CITY of NOVI CITY COUNCIL

Agenda Item 5
June 3, 2019

SUBJECT: Final approval of the request of Erickson Living for JSP 18-18 for the Revised Preliminary Site Plan with PD-1 Option, Revised Special Land Use approval, Revised Phasing Plan, Revised Wetlands Permit, Revised Woodlands Permit, and Revised Storm Water Management Plan, and the Fifth Amendment to the Development Agreement.

FOX RUN NEIGHBORHOOD 3: JSP 18-18

Deviation request Building length:

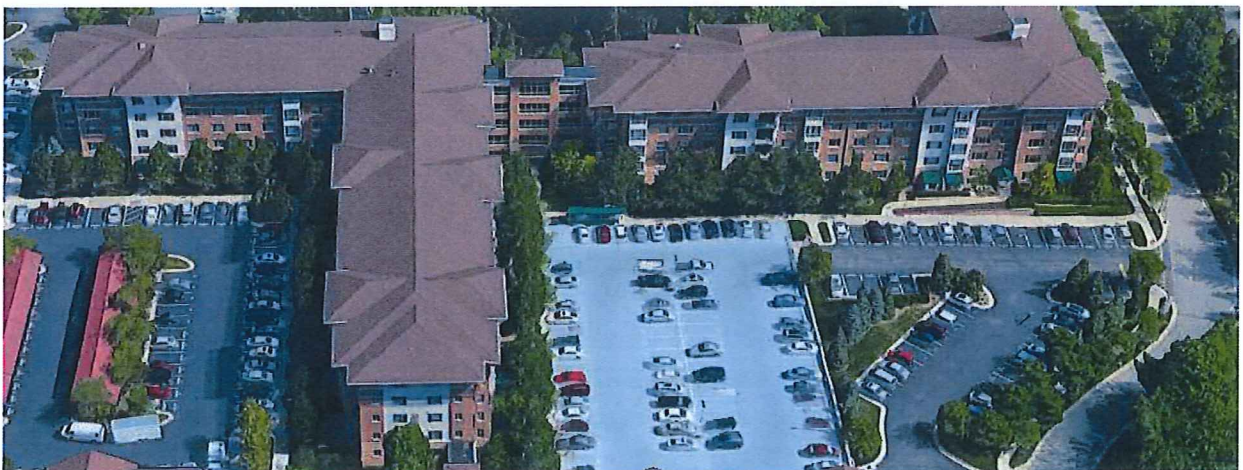
A. That each zoning ordinance provision from which a deviation is sought would, if the deviation were not granted, prohibit an enhancement of the development that would be in the public interest:

All buildings within the existing Fox Run Community are interconnected with pedestrian links, which provide protection from the weather as rain, snow and heat.

This concept allows the senior living residents to move around independently at their own pace to visit the dining venues, live enrichment areas as movie a theater, arts and crafts, game room, etc., or their neighbors. Some residents are fragile and need the handrail support provided along the corridors and pedestrian bridges others use walkers and canes.

Fox Run RB 3.1 Proposed 7 Stories

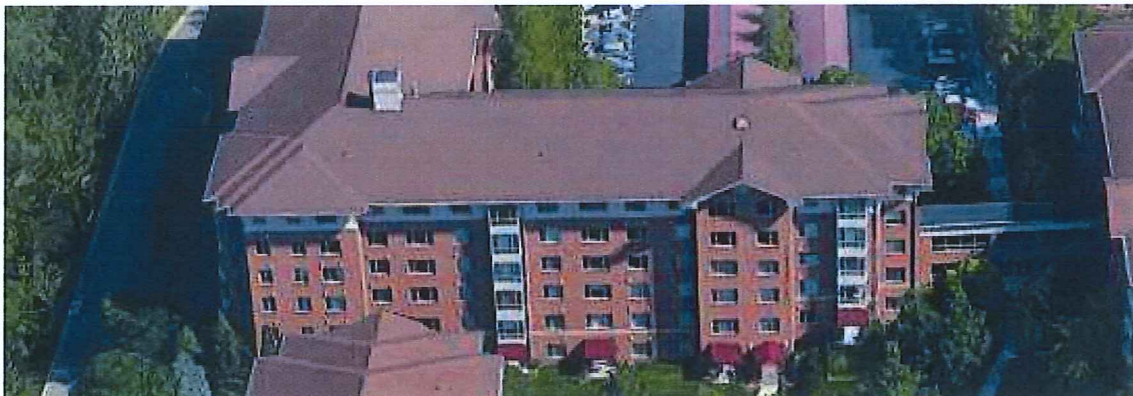
A. That each zoning ordinance provision from which a deviation is sought would, if the deviation were not granted, prohibit an enhancement of the development that would be in the public interest.

The Silent Generation of seniors, born between the years of 1927 and 1945 prefers retirement campus with larger resident units. The average unit size of proposed neighborhood 3 is about 1200 SF in average compared to the 1000 SF average unit size of Neighborhood 1.

Neighborhood 3 was originally planned for 370 resident units as a 5-story building scheme. 370 units are needed to provide a feasible project and balance out the staffing, life enrichment areas as pickle ball, movie theater, game room, and dining venues. We are proposing 370 units as a 7-story building based on the larger market requested unit sizes.

RB 3.1

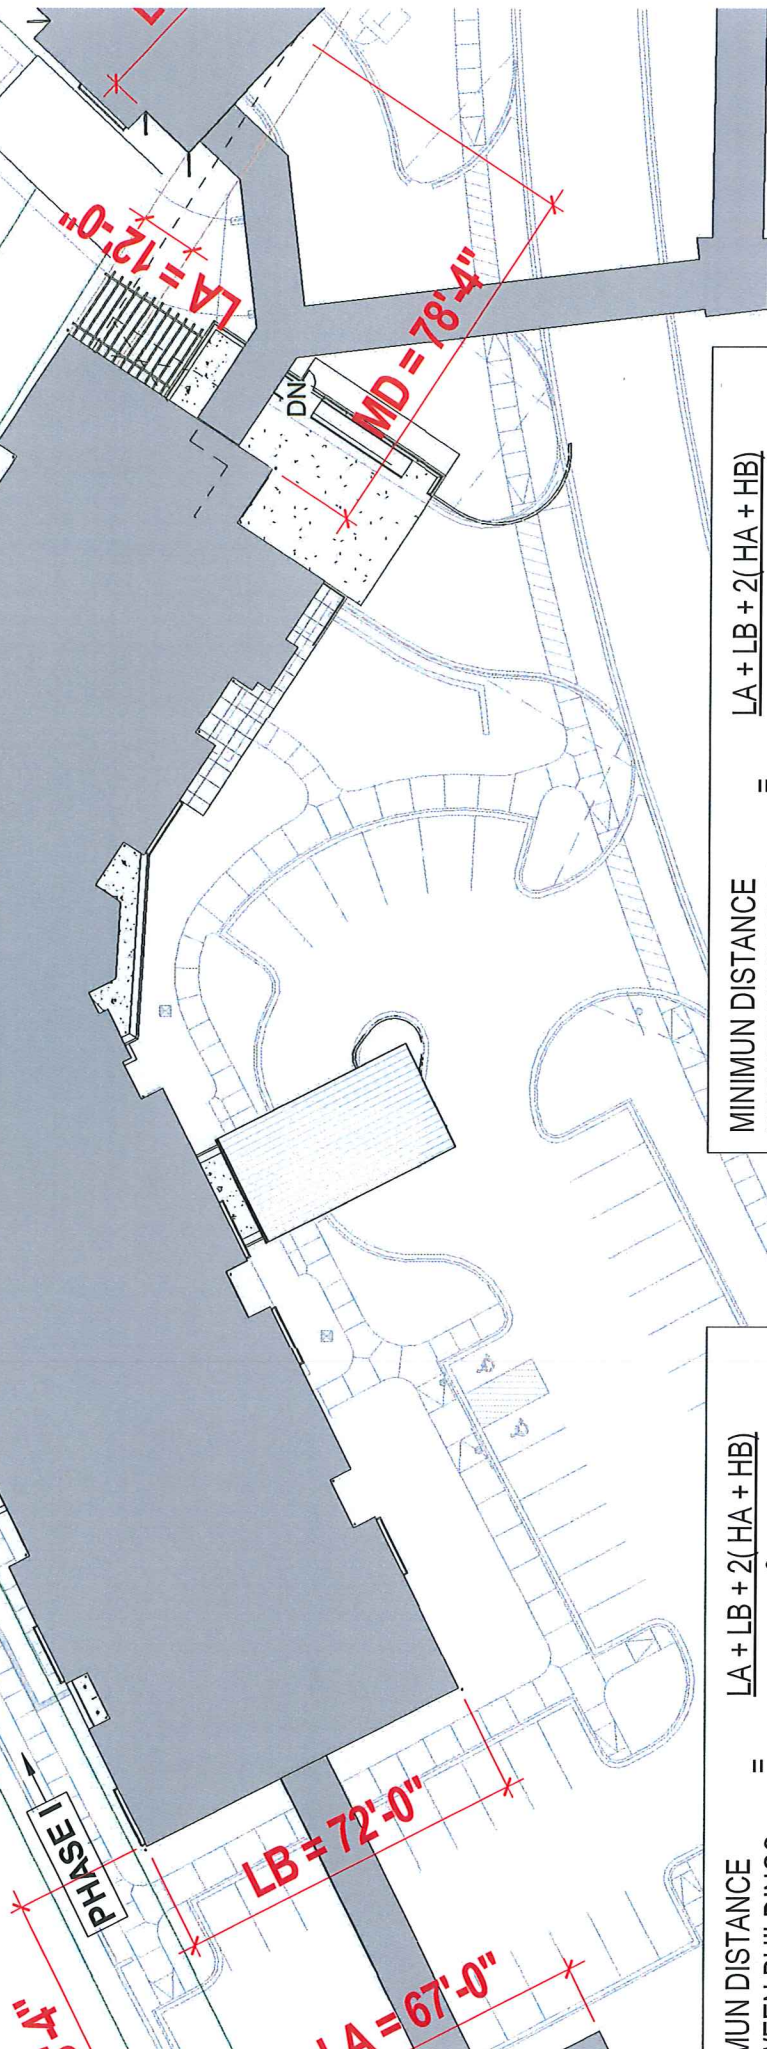
Please refer to enclosed sheet PSP-001, which shows that the current proposed design is within the compliance of distances and spacing per 3.8.2.H of the Zoning ordinance.

MINIMUM DISTANCE BETWEEN BUILDINGS	=	$\frac{LA + LB + 2(HA + HB)}{6}$
MINIMUM DISTANCE BETWEEN BUILDINGS	=	$\frac{12'-0" + 72'-0" + 2(90'-1" + 87'-1")}{6}$
MINIMUM DISTANCE BETWEEN BUILDINGS	=	73'-0 1/2"
